PRODUCT CHANGE NOTIFICATION

#PCN-DC-HEPS-13

Business Unit	Product Line Code	Type of Change	Action	Date of issue
DC	AAA	Mechanical	Notify	6/20/2013
			Distributors	
			and Field

Previous Product

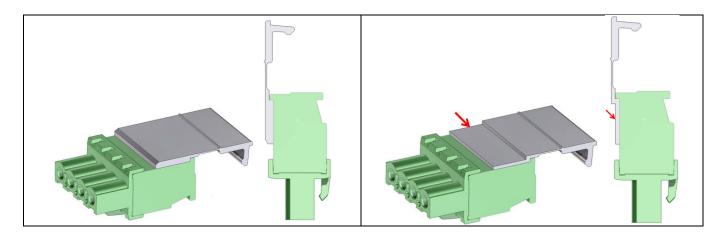
The strain relief tab attached to the plug will have a slightly smaller attachment area to aid in the manufacturing process. Research has indicated that the smaller size assists in the adhering the strain relief tab to the connector body without any change to the strain relief tabs functionality. No features of the plug and strain relief tab have been affected by this change. Depending on current stock levels, both versions of the new and old strain relief tabs will be supplied during the conversion phase.
